Final Environmental Impact Statement for the COB Energy Facility

DOE/EIS-0343

Summary Statement

This summary statement serves as an introduction to the errata sheet for the COB Energy Facility Final Environmental Impact Statement (FEIS). The revisions delineated in this errata sheet update the Draft EIS (DEIS). Background information on DEIS public meetings and comments received is provided below, and the errata sheet format is described.

Figure 2-4
Typical Transmission Tower Structure
COB Energy Facility
Bonanza, OR

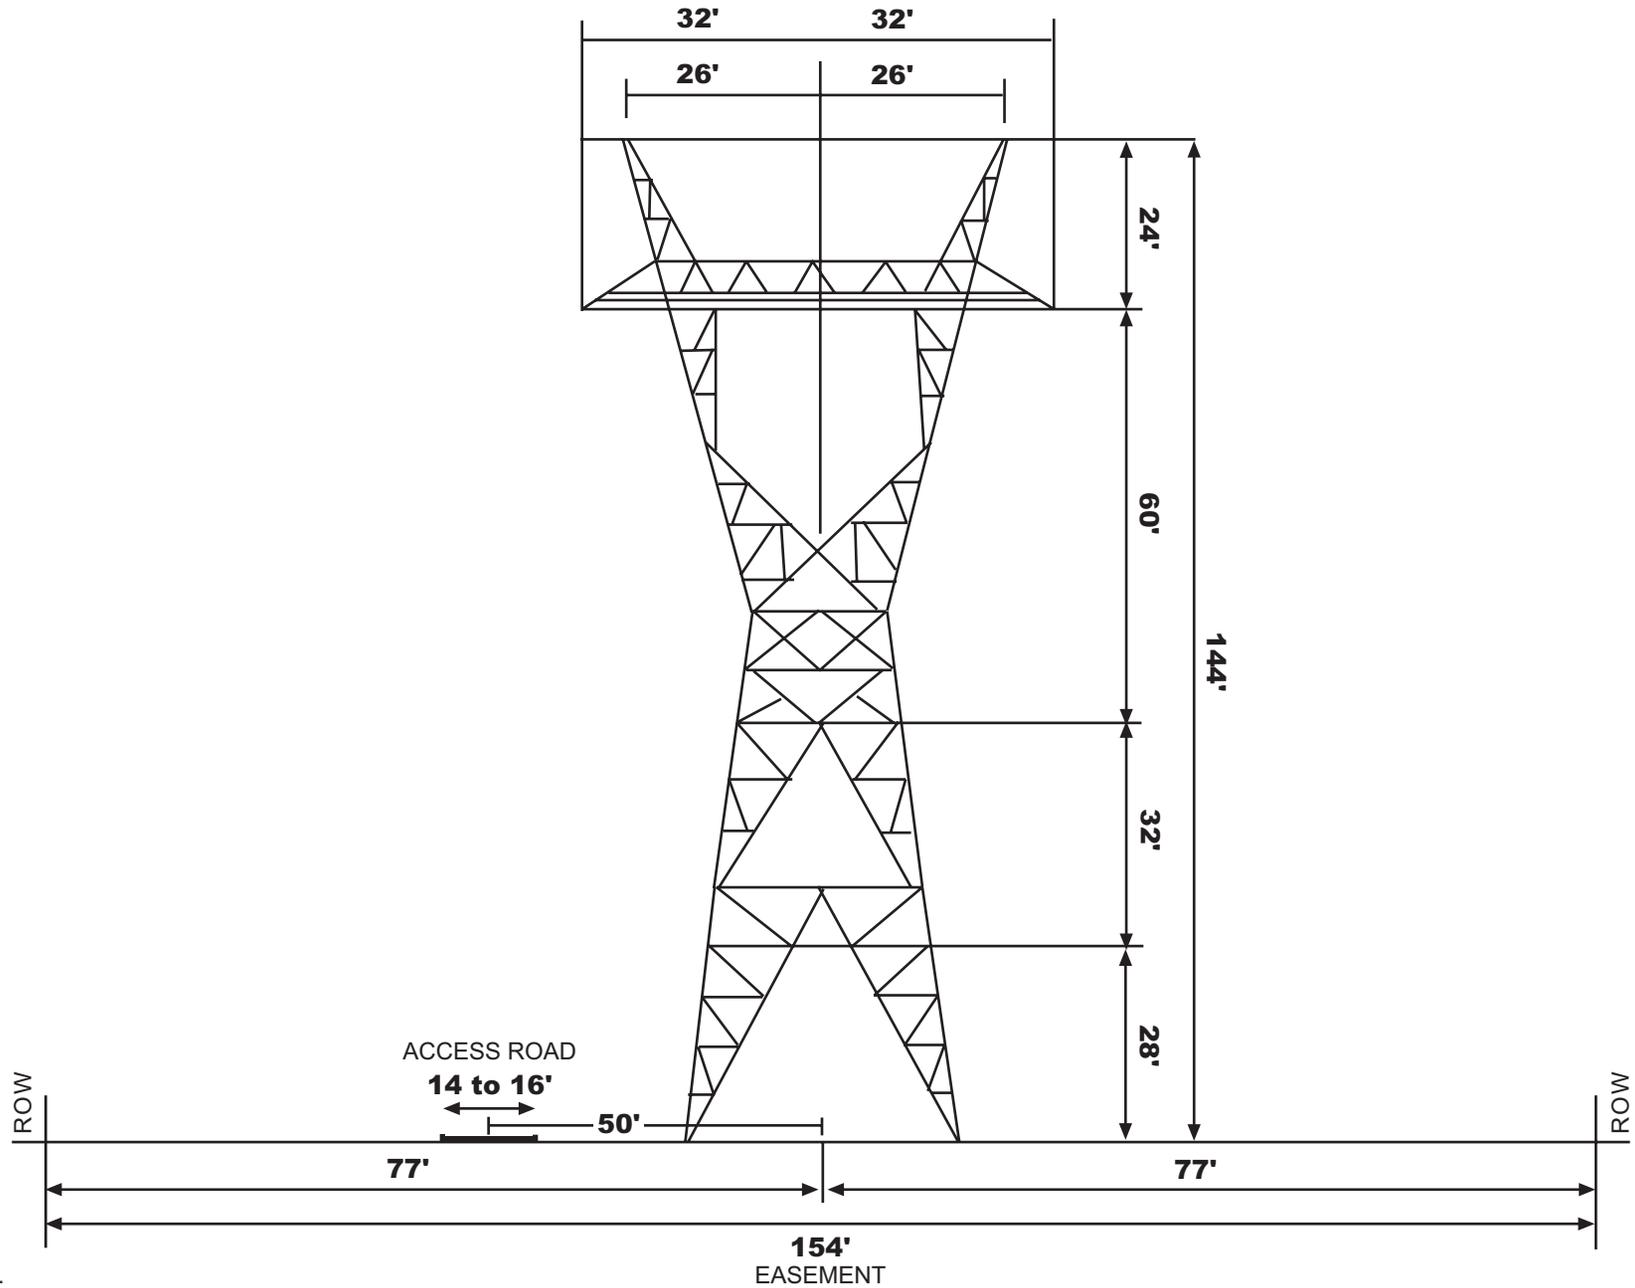
28T1	<p>Add, Impact of Proposed Action/Mitigation, 3.1.3: <u>The proposed project facilities and transmission towers may impact scenic views for recreational users in the vicinity of the project but would not affect recreational public or private facilities.</u></p>
Chapter 2 Figures			<p>Revised Figure 2-2. <u>Figure 2-2 will be revised to show BLM-managed land. Figures 2-3 and 2-6 will be added. Figures 2-4 and 2-5 will be renumbered. See Part 3 New and Revised Figures.</u></p>

Figure 2-5
Typical Water Supply Pipeline Configuration
Biological Assessment
COB Energy Facility
Bonanza, OR

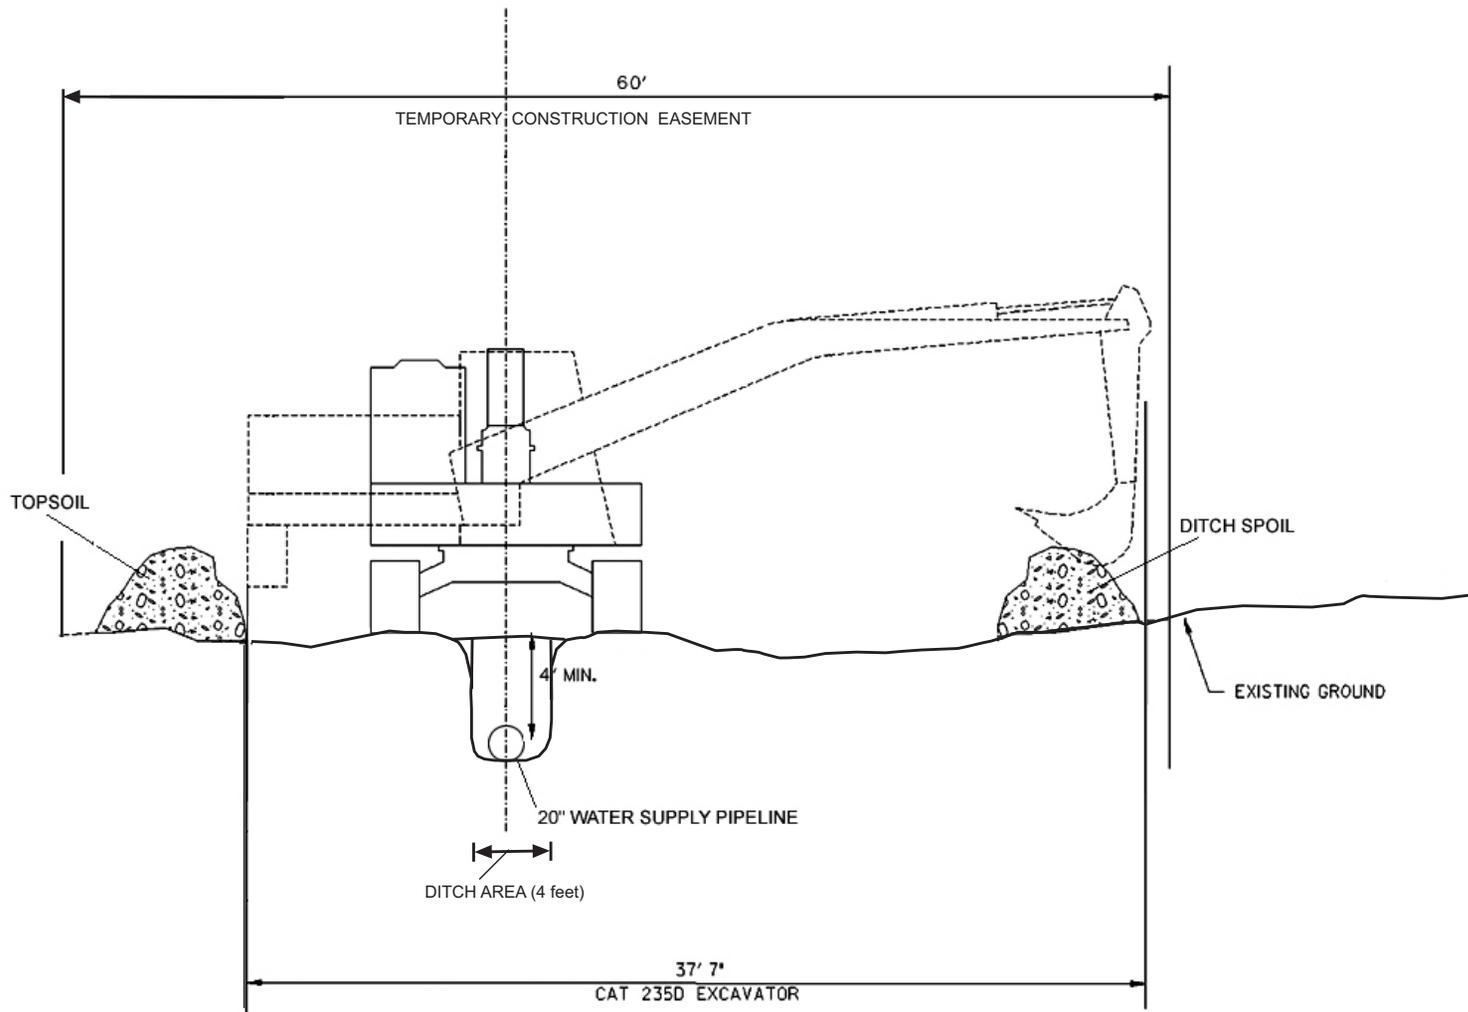
The water supply pipeline would be installed in a 36-inch-wide trench at a depth of about 4 feet. The trench would be backfilled with pipe zone material and then with native soil up to the original grade. Figure 2-54 shows a typical section of the water supply pipelines.

Figure 2-6
 City of Malin Visual Resource Map
 COB Energy Facility
 Bonanza, OR

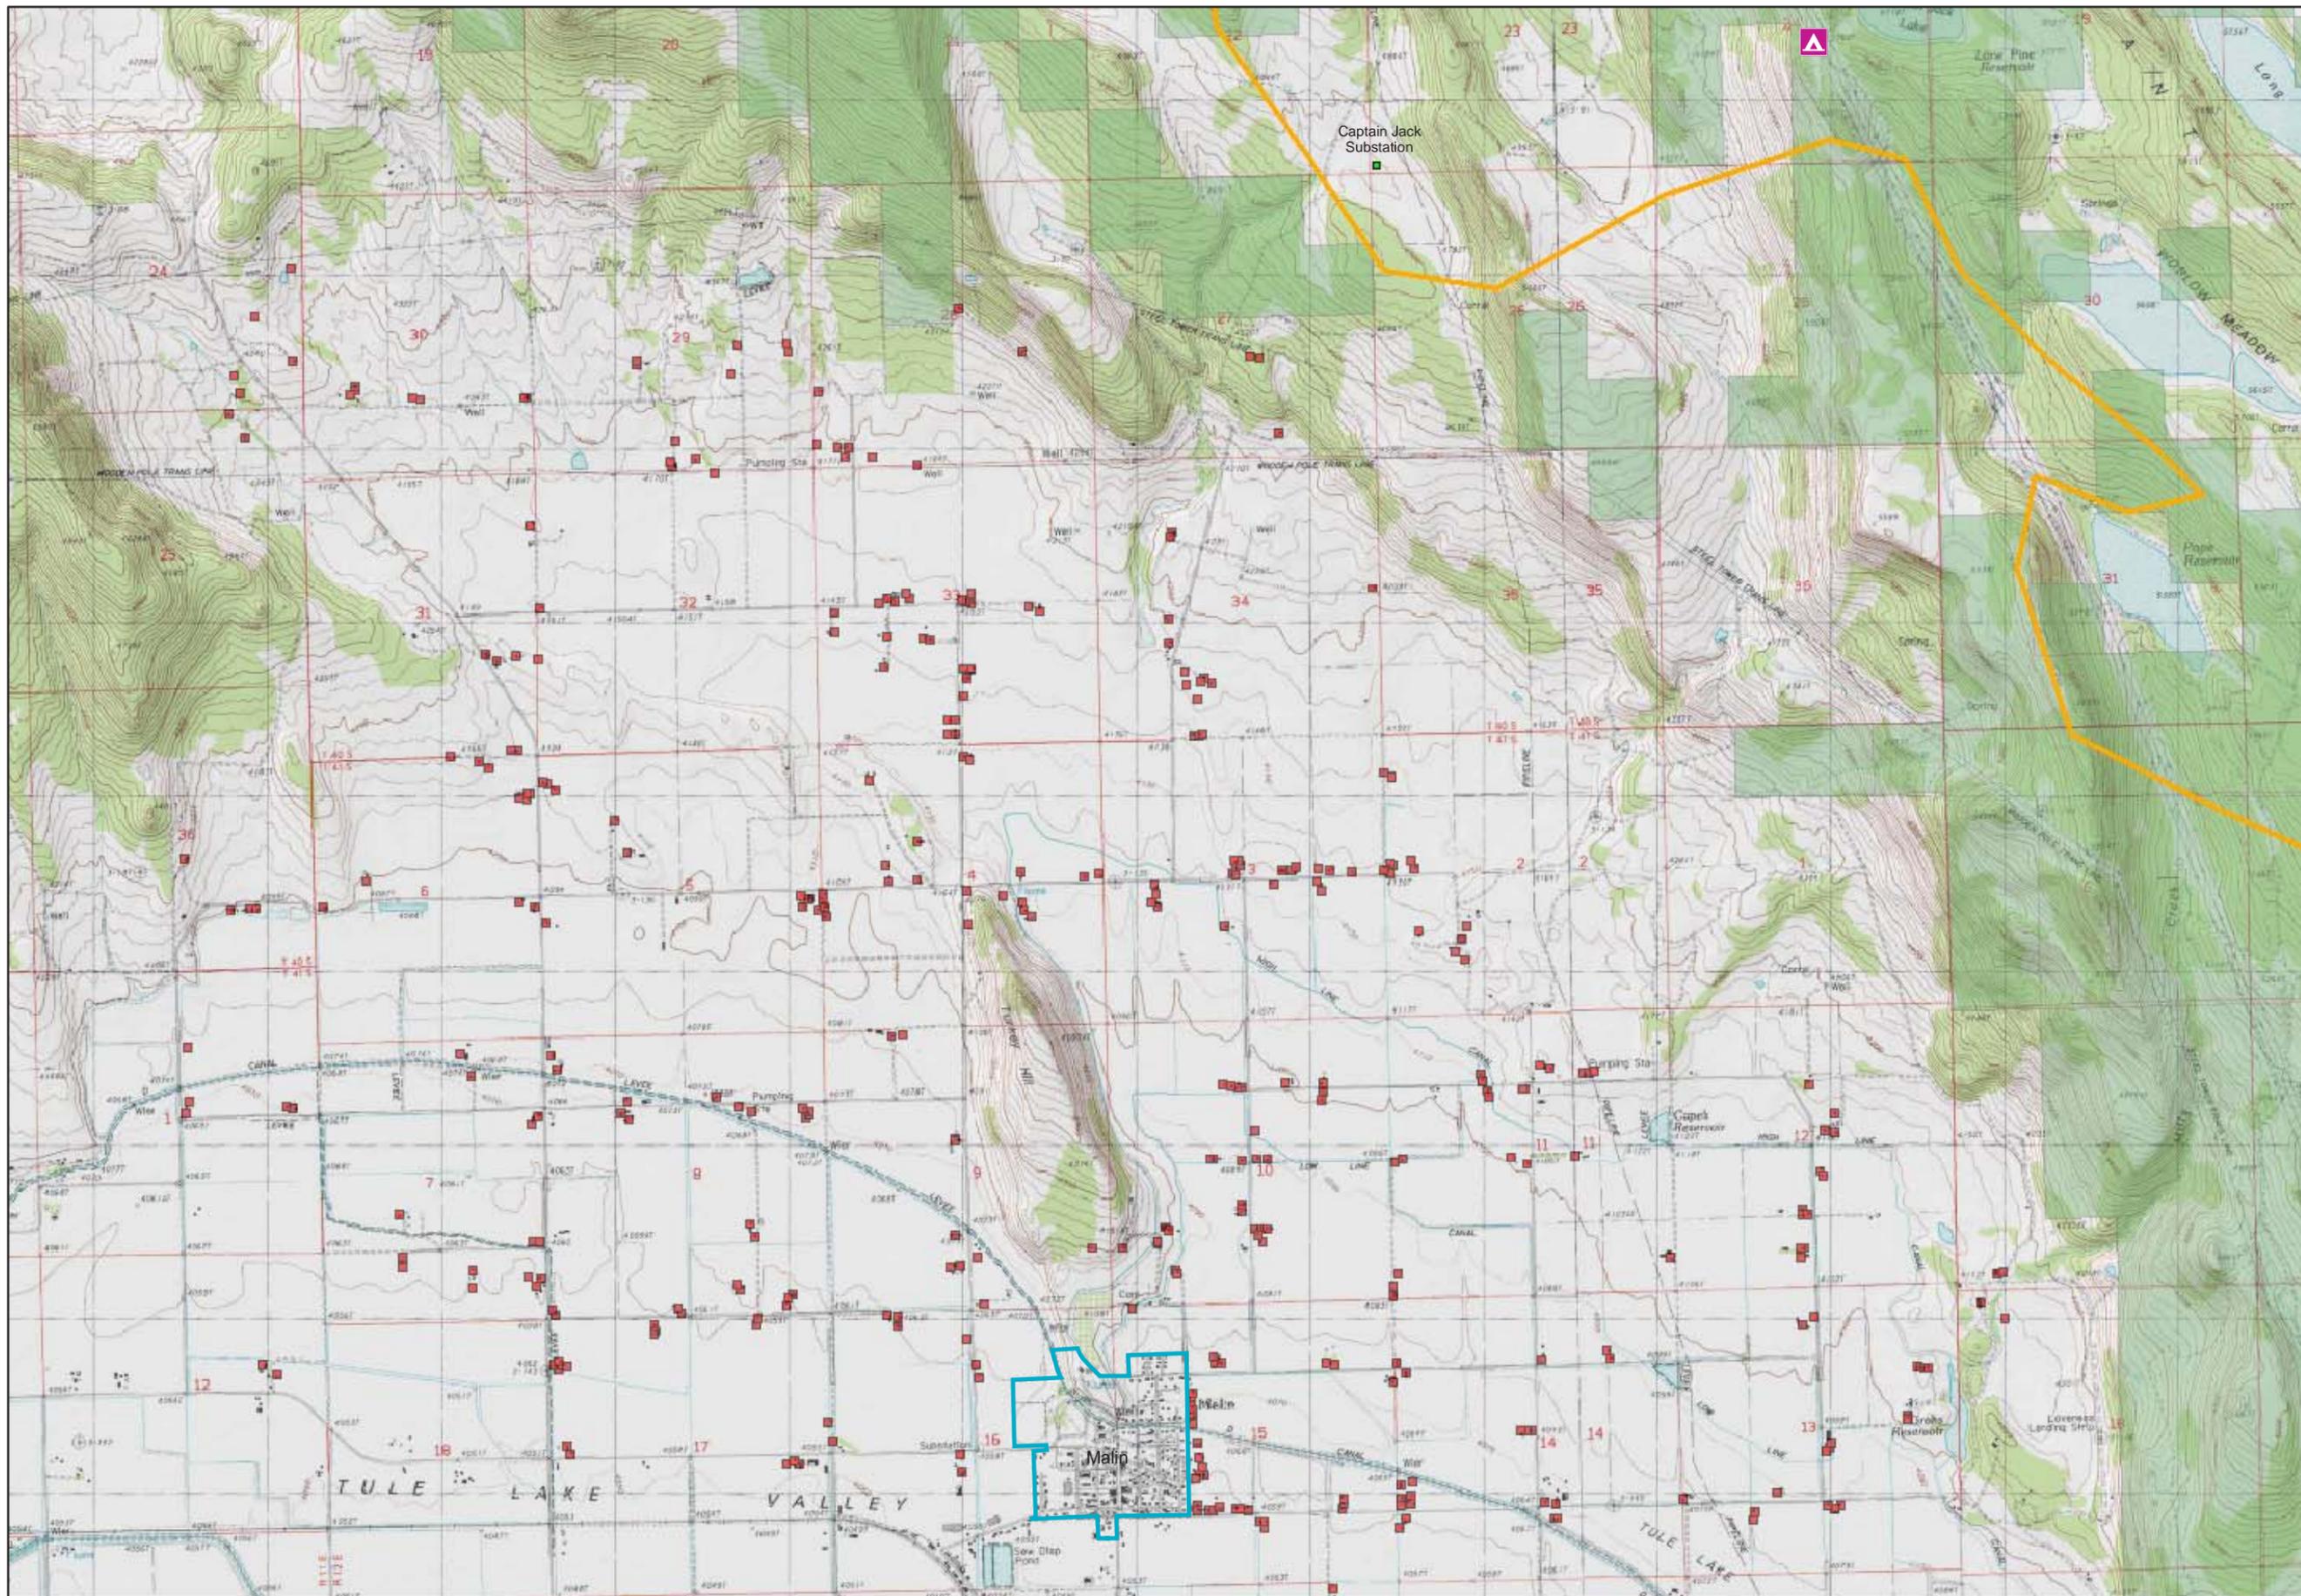
Table 3.8-1	3.8-7	28U5	Revisions to the Table. See Part 2 New or Revised Tables.
Figure 3.8-1 and 3.8-2	3.8-8 3.8-9	28W5	Revisions to the Figure. See Part 3 New or Revised Figures.
